City of Bristol
Conservation Commission/ Inland Wetlands and Watercourses Agency

REGULAR MEETING OF MONDAY, DECEMBER 1, 2025
MEETING ONLINE VIA ZOOM AND
BRISTOL CITY HALL – COUNCIL CHAMBERS
111 NORTH MAIN STREET
6:30 PM

**INLAND WETLANDS & WATERCOURSES AGENCY
OF THE CONSERVATION COMMISSION OF THE CITY OF BRISTOL
MINUTES
REGULAR MEETING OF MONDAY November 3, 2025
DRAFT MINUTES - JL**

Figure 1 – Perennial Springs

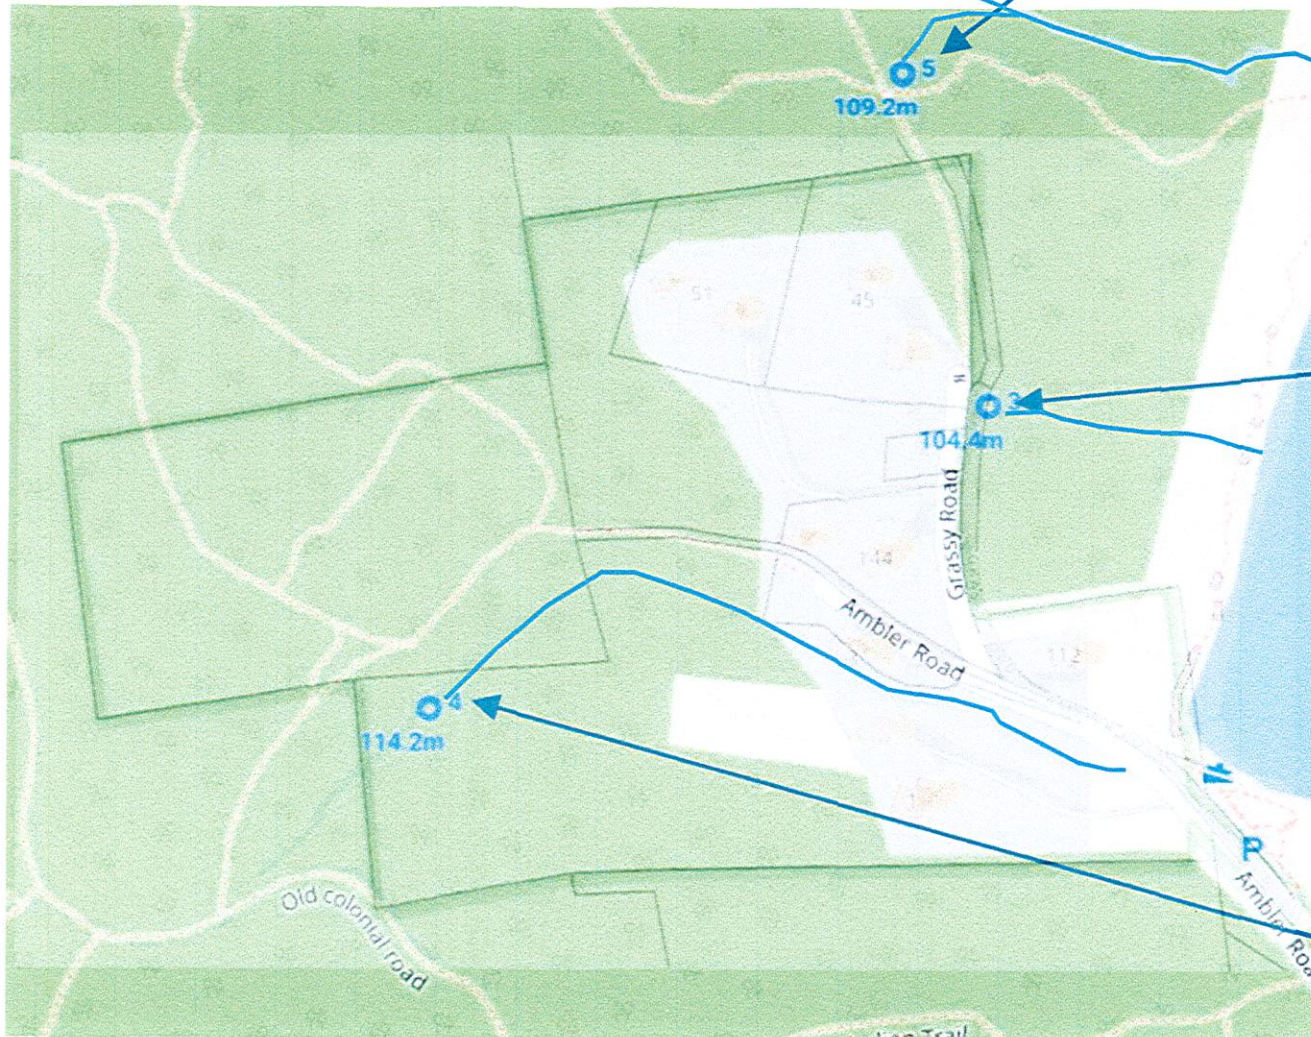
Michelle Rudy, 102 Henderson St, we are trying to call for a soil analysis of the area, because we have documented these springs. And, the commission can actually go out there with these coordinates and locate the springs. So, this is a question of surface water, which doesn't need a soil analysis, but... the surrounding wetlands need to be characterized. And that's something that still needs to be done in order to meet the definition of the wetlands, in the regulations.

Michelle Rudy, 102 Henderson St, Correct. So, Erik Spring is a little spring that moves into a wetland that is on the map. But it is closer to the property than what the map states.

Michelle Rudy, 102 Henderson St, Correct. So that's why we're calling for the applicant to do their due diligence and proving that the wetland soils are where they are supposed to be on the map, because you can actually go out there yourself with our coordinates and locate the springs.

Culvert Details
Scale: 1/4" = 12"
Date: 10/21/2025
Drawing No.: S1

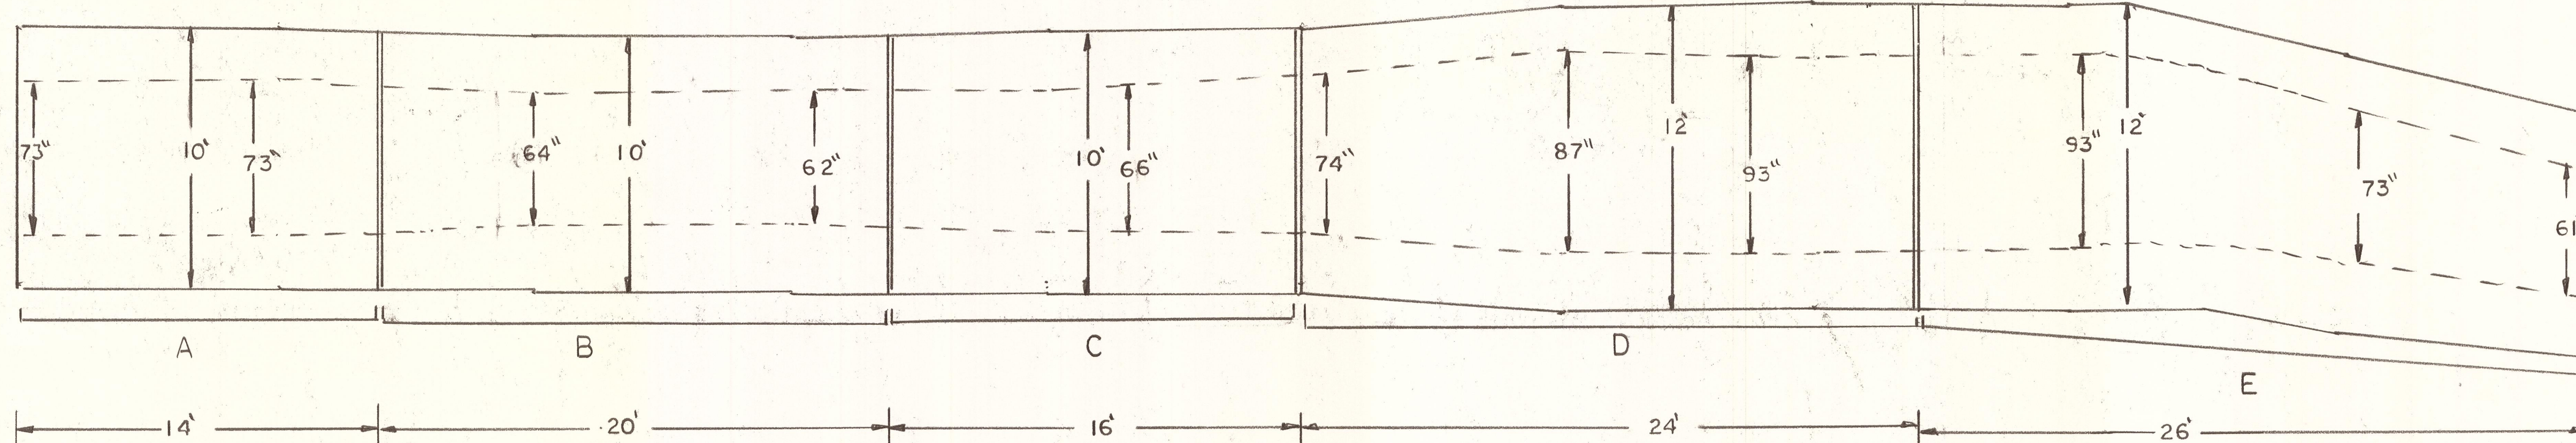
Commissioner Rooks, I am asking you because I do not see plans in front of me. Well, if you're repairing it, I would say, you know. If you're repairing it, you should be repairing it with a 7-inch thick, and we'll deal with that later down the road, but I understand what you're trying to do is fix it properly, but the sidewalls, you put something heavier on it, it could fall in.

Anthony Lorenzetti, City Staff, is that in the plans you submitted tonight?

William Stango, City Engineer, Correct, that is going to be needed. That's... that's something to determine, at the very least, a typical section. What are we doing in the waterway? Where's the riprap? What will the proposed hydraulic opening look like? Correct. How can we enforce that? and this is my opinion, if we don't know what will be proposed, how can we say this is approved, we don't have a proposed cross-section of the work?

William Stango, City Engineer, I can do my best to reiterate all those. Just quickly reiterate them. The most important... Because I think these will be used in our determination. The most important is a typical cross-section of the proposed work. What is existing, and how will it be affected? How will the hydraulic opening be impacted, if any? We also need survey to show who the property owners, and signature, to show that all the affected property owners have signed off on this application. s well as elevation and grade of channel invert and low cord elevation of the culvert. That will tell us the hydraulic opening. It is the cross section, the invert. and the low cord elevation of the culvert. That's what we need to determine the impact of the existing channel.

Curt Freedman, P.E., 24 Ridge Rd., Longmeadow, MA 01106, Yeah, the details call for the slab with the top deck of the culvert to be removed. And then be restored in place as kind, as it is. Now, we're not looking to change those dimensions at all.

Curt Freedman, P.E., 24 Ridge Rd., Longmeadow, MA 01106, The side walls are stone and the stone on the inside are all of them, right? In some of that culvert? But what's fallen in is approximately 4 inches of poured concrete, which lined the stone. And the photographs show that's what was scoured away in that location. We're going to, install anchors, and then put a new inner lining concrete in that location to restore it to where it previously was.
